Date: 26 April 2021
Reference: L2466

Bridge House, Oxford Road, Uxbridge UB8 1HS

The Hierarchy of Drainage

The proposed surface water discharge is to the River Colne via a 178m³ attenuation with a permavoid biomat. This is detailed on drawing BRH-PRJ-XX-00-DR-C-07000, extract below.

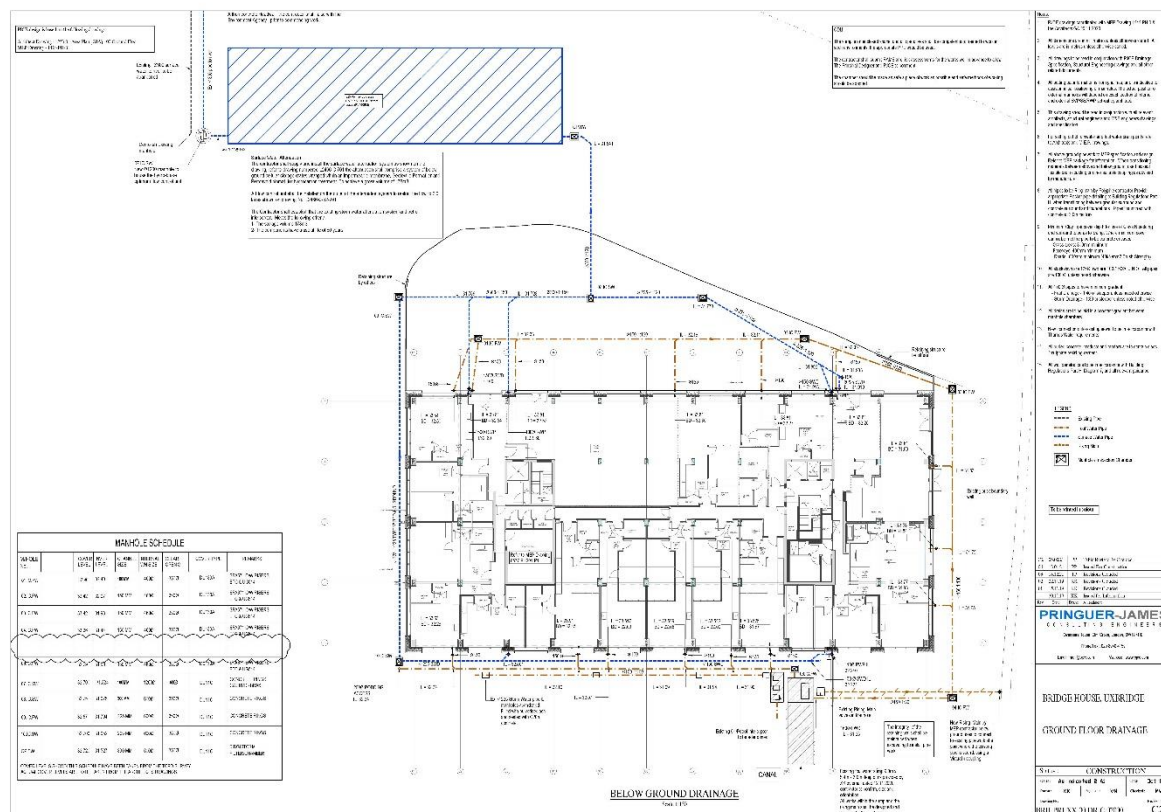
"The Council's Flood and Water Management Officer has reviewed the submitted details and stated that the proposed discharge rates are considered acceptable, however it is not clear that this is the most sustainable design, and that more sustainable options cannot be included. Are you able to provide additional information clarifying this point?"

The site is straddled by the River Colne, in the north and the Canal in the south. The most appropriate discharge for the surface water is to the adjacent River Colne.
